Access Compliance Report

Public Rights-of-Way

Intersection ID: N/A	Main Street: BROOKSIDE_LN	Cross Street: N/A	Location: SW
ADA ID: 146B7C273837	Ramp Type: Directional	Initial Pass/Fail: Fail	Overall Compliance: No
		Severity Score: 1.25

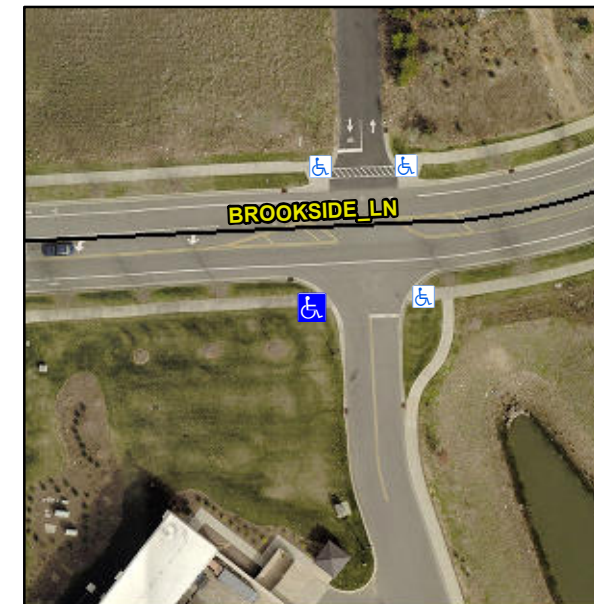
R304.5.3

Compliance	Description	Data	Compliance	Description	Data
N/A	Ramp Length (in)	119.0	N/A	Grade Break?	N/A
Yes	Ramp Width (in)	71.0	N/A	Grade Break Slope (%)	0.0
Yes	Ramp Slope (%)	7.3	N/A	Grade Break XSlope (%)	0.0
No	Ramp XSlope (%)	3.8			
N/A	Flare Type LT	N/A	N/A	Flare Type RT	N/A
N/A	Flare Slope LT (%)	N/A	N/A	Flare Slope RT (%)	0.0
N/A	Flare Traversable LT?	N/A	N/A	Flare Traversable RT?	N/A
N/A	Landing Length (in)	0.0	N/A	DWS Provided?	N/A
N/A	Landing Width (in)	0.0	N/A	DWS Contrast?	N/A
N/A	Landing Slope (%)	0.0	N/A	DWS Length (in)	N/A
N/A	Landing X Slope (%)	0.0	N/A	DWS Full Width?	N/A
N/A	Landing Curb? (Y/N)	N/A	N/A	DWS Offset LT (in)	N/A
N/A	Shared Landing?	N/A	N/A	DWS Offset RT (in)	N/A
N/A	Gutter Ponding?	0.0	N/A	Gutter Slope (%)	N/A
N/A	Gutter Lip Ht (in)	0.0	N/A	Gutter X Slope (%)	N/A
N/A	Painted X Walk1?	No		Road Slope (%)	1.7
	X Walk 1 Direction	To NE		Road X Slope (%)	1.2
	X Walk 1 Width (in)	N/A		Clear Space?	N/A

Remove & Replace Entire Ramp.
